REGULAR MEETING – PLANNING AND ZONING COMMISSION AGENDA

**JULY 2, 2025, 6:00 PM
BY ZOOM VIRTUAL MEETING**

- A. #2025-47 SP - 186 Westport Ave LLC - 186 Westport Avenue (District 5, Block 4, Lot 151) - Special permit for existing car wash to add motor vehicle repair use - Public hearing, report & recommended action**
- B. #2025-40 SP - Mayra Garcia - 43 Bettswood Road (District 5, Block 5, Lot 70) - Special permit application for a Child Day-Care Center use - Public hearing, report & recommended action**

- A. #2025-52 SP Modification - St. George Greek Orthodox Church - 238 West Rocks**

REGULAR PARKING SPACE
N.T.S.

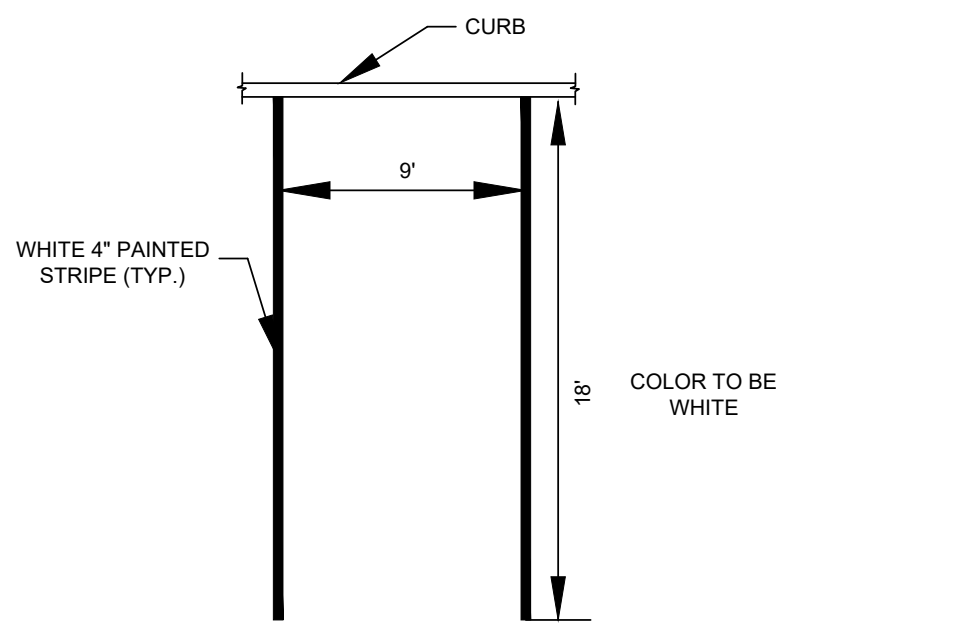
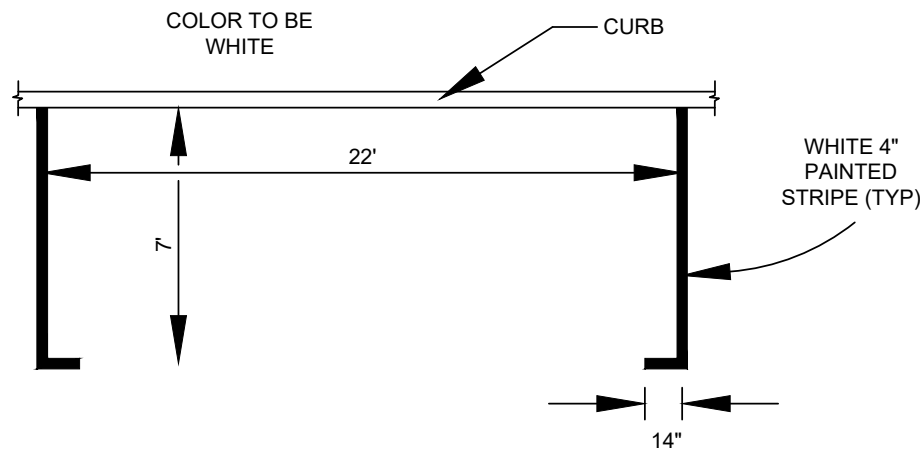
1. Please confirm whether the driveways are both one-way (i.e. the east driveway curb cut is enter only and the west driveway curb cut is exit only) due to the narrow width of the loop driveway. If so, will there be signage installed to clarify the entry and exit?
2. Please rectify the discrepancy between the parallel parking space detail on Sheet SE-2 and the dimensions on the plan (Sheet ZSP-1).
